## Industry/TSTF Standard Technical Specification Change Traveler

### Charging Pump Swap LTOP Allowance

1. Delete NUREG-1431 and NUREG-1432 LCO 3.4.12 Required Action B.1 Note.
2. Delete NUREG-1430 LCO 3.4.12 Required Action A.1 Note
3. Add new Note to LCO 3.4.12.
4. Move Applicability Note to LCO 3.4.12.
5. Modify Bases accordingly.
6. Clarify Bases discussion of LCO requirement.

RCS Vent Performance

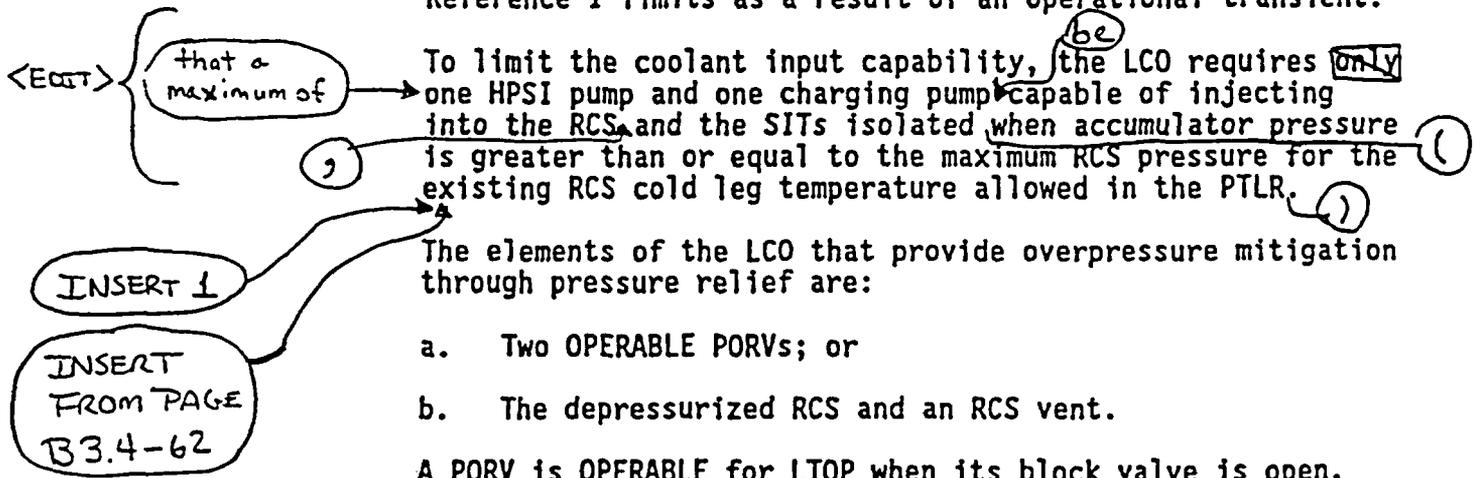
To limit the coolant input capability, <sup>be</sup> the LCO requires only one HPSI pump and one charging pump <sup>9</sup> capable of injecting into the RCS, and the SITs isolated when accumulator pressure is greater than or equal to the maximum RCS pressure for the existing RCS cold leg temperature allowed in the PTLR. <sup>1</sup>
